# WATERLOO METRO QUARTER BUILDING 3&4

SSD-10437 - RESPONSES TO DPIE

PREPARED FOR WATERLOO DEVELOPER PTY LTD  
DOCUMENT NO. WMQ-BLD34-BSA-AR-RPT-DA211

Indicative Potential Layout for a Makerspace  
(as presented at DRP Presentation 12 - 28.01.2021)

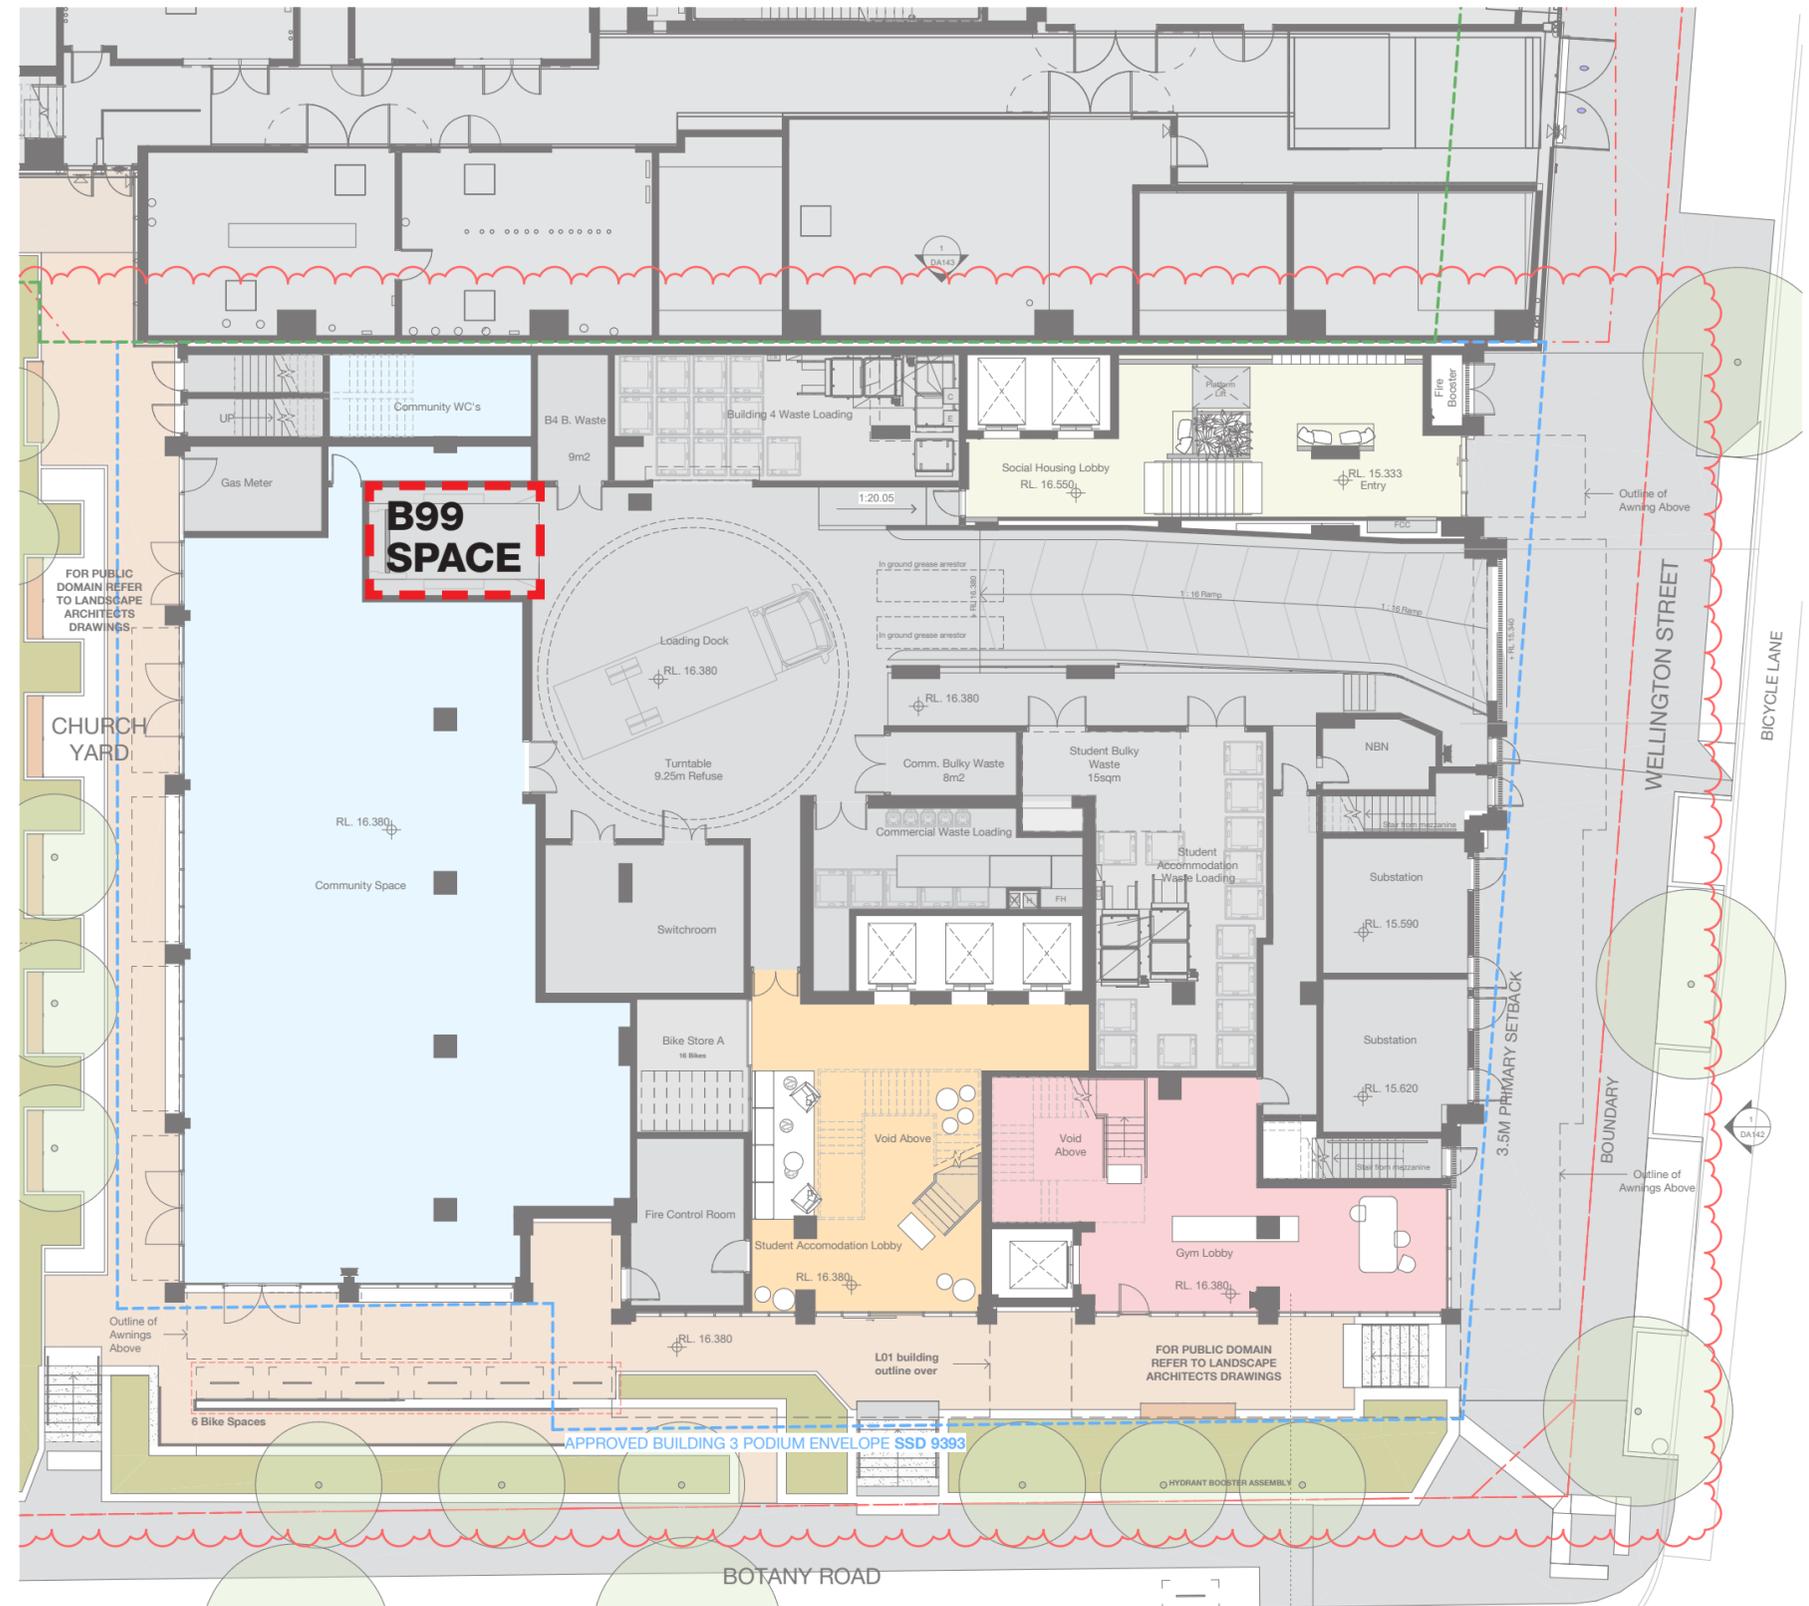
The layout of the Makerspace is compromised by the addition of the B99 service vehicle space. City staff recommend that any additional space required for servicing to be reallocated from the gym area.

Space on the ground floor is constrained due to the servicing and back house requirements for four building occupants (Student Accommodation, Social Housing, Makerspace, Gym). The B99 space has been co-located with the loading dock to consolidate similar uses and to limit the quantity of vehicular entries on the facade.

Active frontages have been maximised where possible. The gym area on ground floor is relatively modest in space serving as the gym lobby, reception and vertical circulation space. Re-allocating area from the gym for the B99 space would reduce the active street frontages.

The Makerspace plan diagram (right) demonstrates a potential layout that prioritises the active functions along the frontages to Botany Road and Church Yard. We anticipate the Makerspace area behind the B99 parking space will be used for ancillary functions such as toilets and storage.

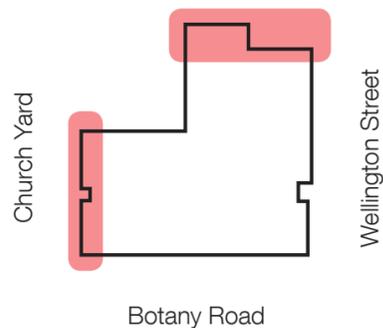
The additional glazing is acceptable, however, there is no variation in the colour of the grid and infill panels of the north or east walls. This monotony could be better treated with some variety in colour. A condition to this effect is recommended.  
(City of Sydney)

The design of the building ends have been developed in response to feedback from the DRP to ensure the facade design to these elevations are highly considered.

We believe the proposed design has a considered balance between built form articulation, fenestration and architectural expression through the expressed grid frame.

We have avoided pattern making through a variety of panel colours, instead favouring a more simple, elegant approach in keeping with the overall building architecture.

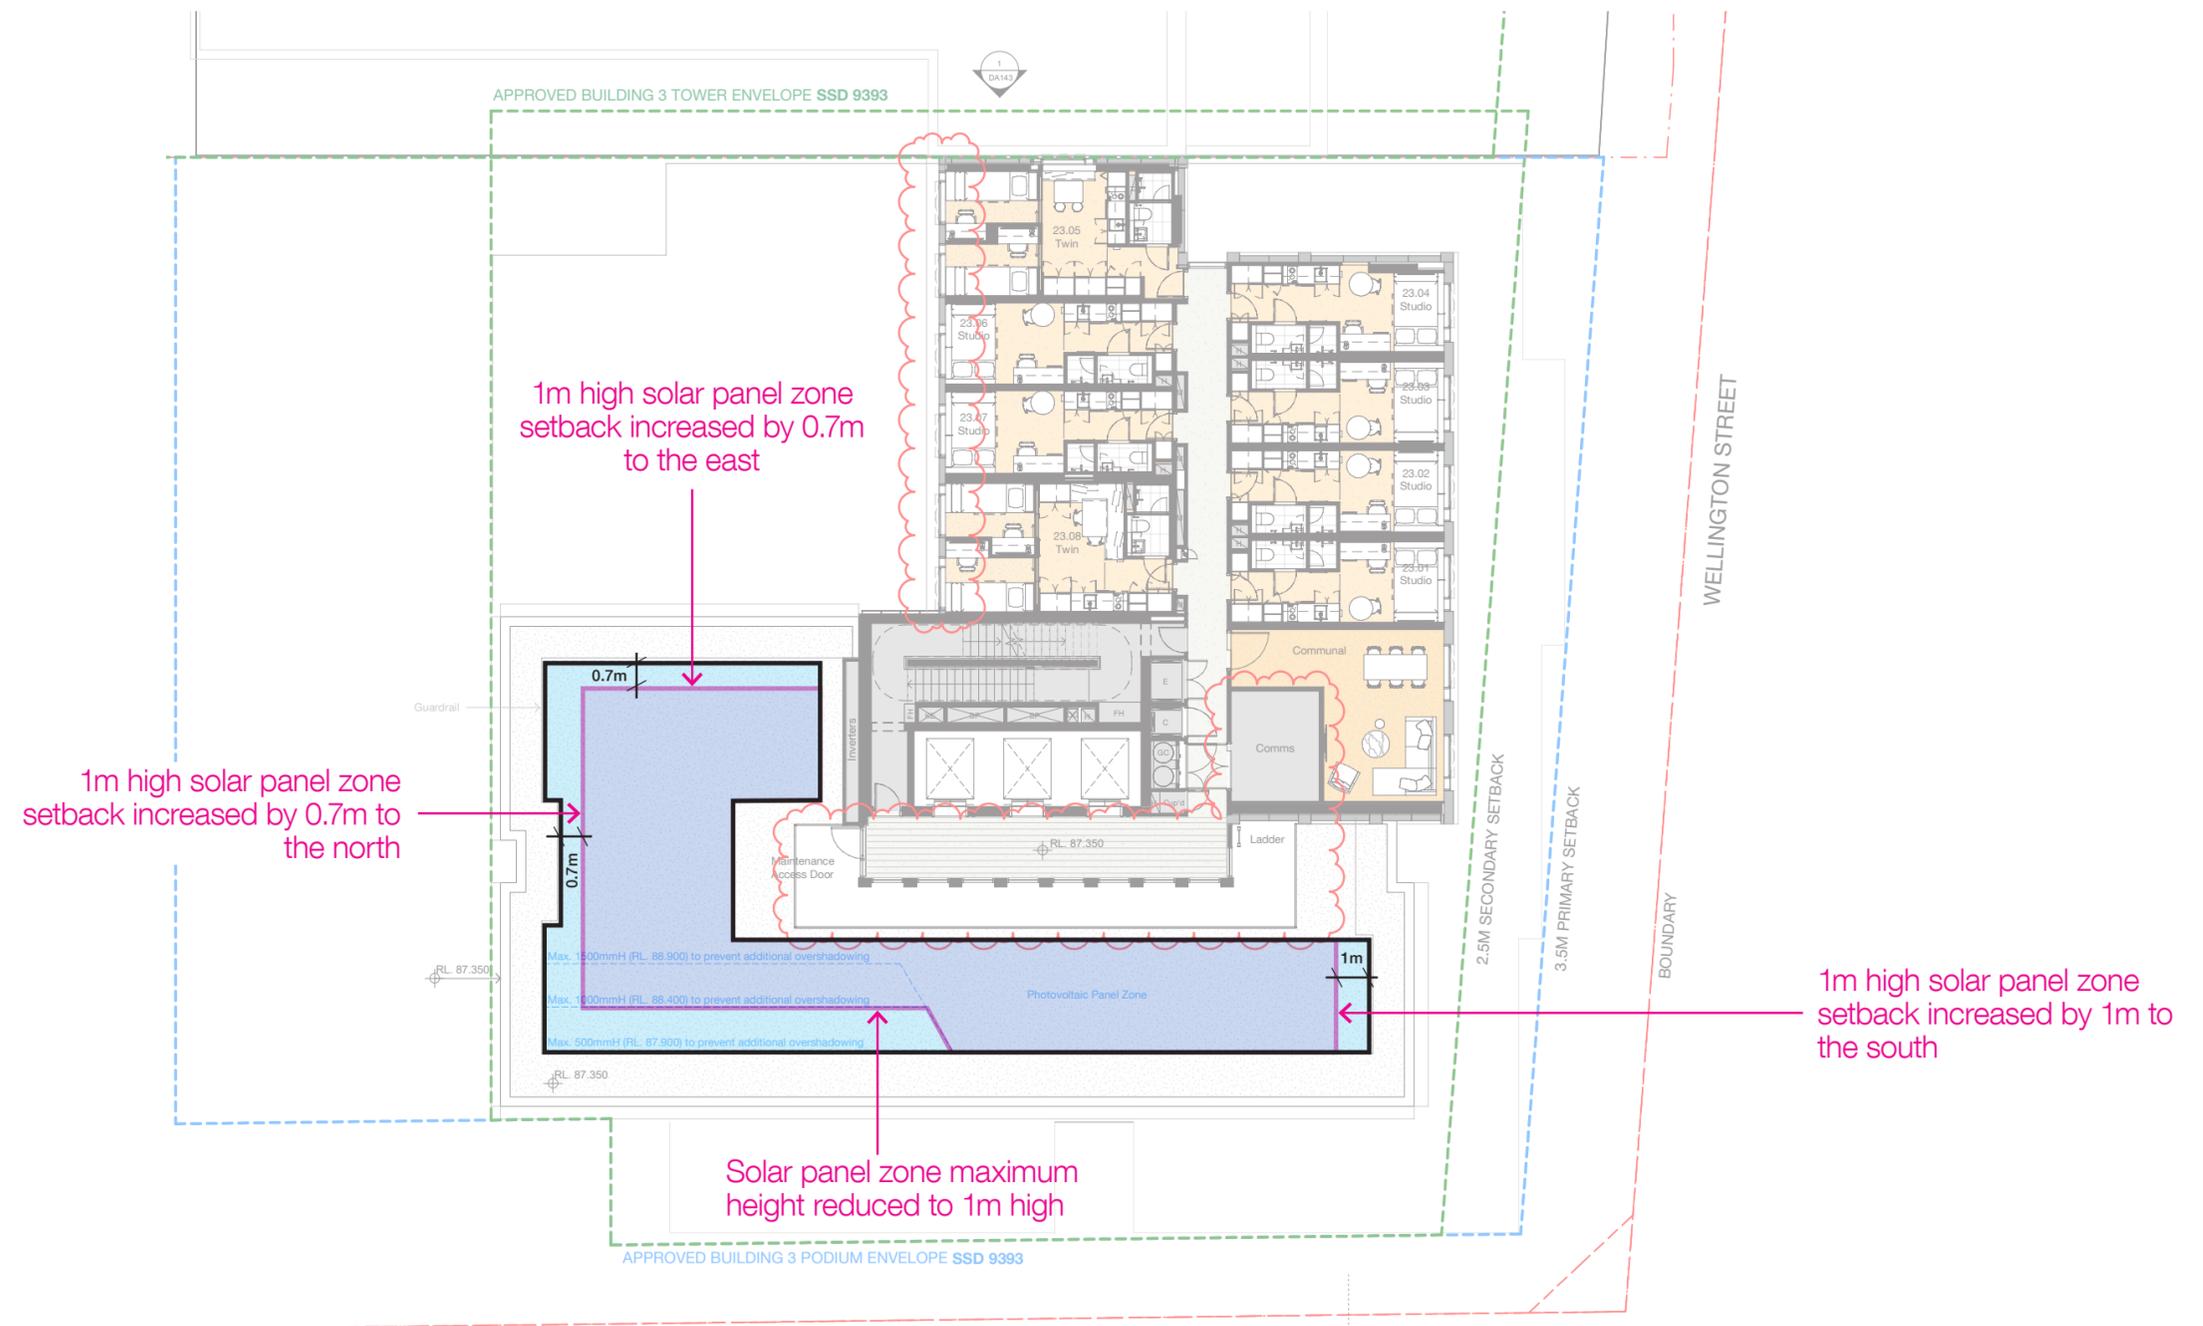
The height of the parapet on Building 3 identified in the image below should be extended from RL 87.35 to RL 88.9 to conceal views of the solar panels from the surrounding area whilst allowing for unobstructed solar access. All other parapets should be raised to a minimum 1.5 metres above the corresponding finished roof level, subject to mitigating any overshadowing impacts on Alexandria Park.

The height of the current Building 3 parapet is designed to minimise overshadowing of Alexandria Park. Any additional height along the building edge above that shown in the SSDA drawings will increase overshadowing to Alexandria Park.

To mitigate visibility from the surrounding area, the solar panel zone is proposed to be adjusted by reducing the overall maximum height from 1.5m to 1m, and increasing the setback to the north, south and east. The diagram on the right illustrates the revised extents.

Given the revised setback and height of the panel zone, the proposed panels are not expected to be highly visible from the surrounding streets. Refer to the images on the following slides for view impact studies from the surrounding area.

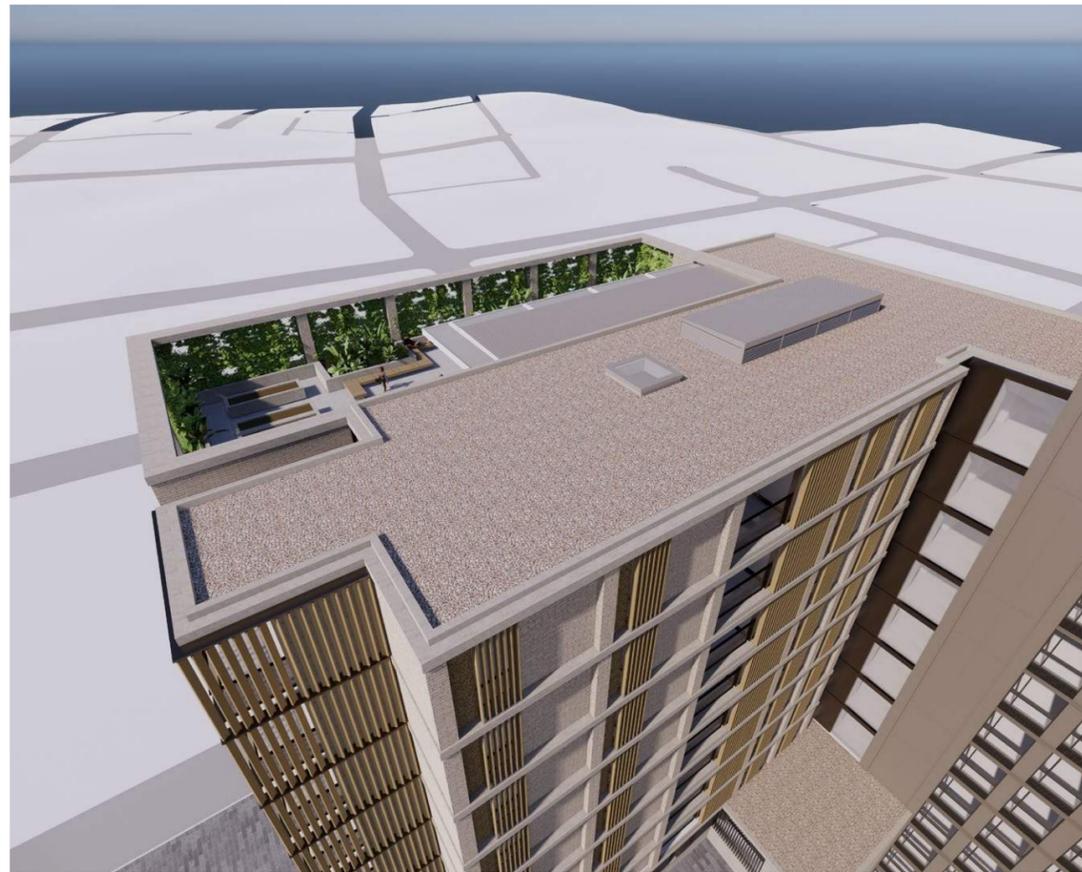
The height of the parapet on Building 4 should be similarly increased by a minimum of 1 metre to obscure any services, exhausts, plant and the like, subject to mitigating any overshadowing impacts. This would result in an exceedance to the stage 1 building envelope but comply with the maximum RL96.9 permitted for the site.

The Building 4 roof is proposed to have a gravel finish to maintain reasonable visual amenity. A revised setback parapet detail around the building edge to allow for a sufficient gravel depth has been presented to the DRP. Increasing the parapet to 1m high would impact the proposed building form and architectural design whilst increasing overshadowing.

## BUILDING 3 MATERIALS BOARD

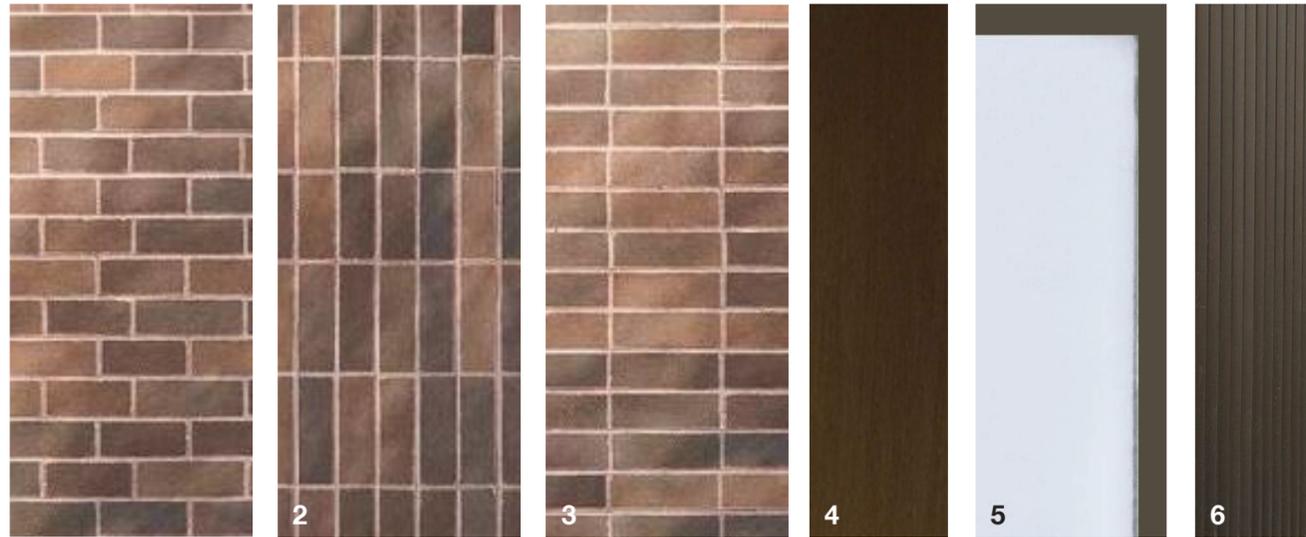
Any condition of consent regarding materials selection must require specifics including colour, material and where relevant manufacturer. Words such as “or similar” should not be permitted on the drawings. No substitutes should be permitted without the approval of an independent Design Review Panel.

The proposed materials and finishes have been presented at DRP Presentation 12, with the increased level of detail being supported by the panel. The materiality for the Building 3 podium is shown here.

The bricks for the podium are intended to relate to the materiality of the local context, without trying to mimic it. Dry pressed bricks are proposed for their textural quality and the range of tones that are produced from a single brick type.

## BUILDING 4 MATERIALS BOARD

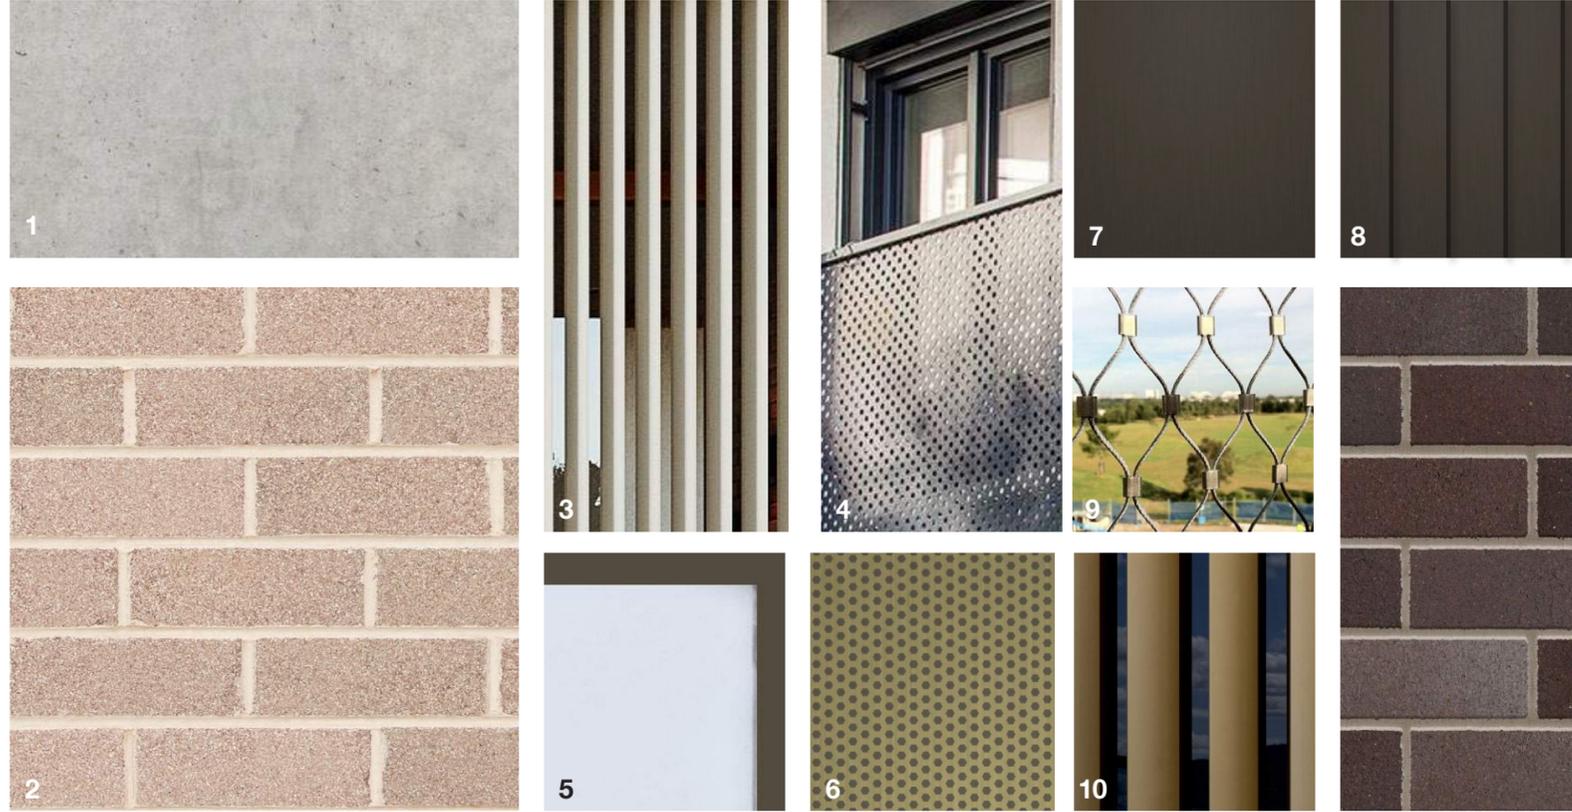
Any condition of consent regarding materials selection must require specifics including colour, material and where relevant manufacturer. Words such as “or similar” should not be permitted on the drawings. No substitutes should be permitted without the approval of an independent Design Review Panel. (City of Sydney)

The proposed materials and finishes have been presented at DRP Presentation 12, with the increased level of detail being supported by the panel. The materiality for Building 4 is shown here.
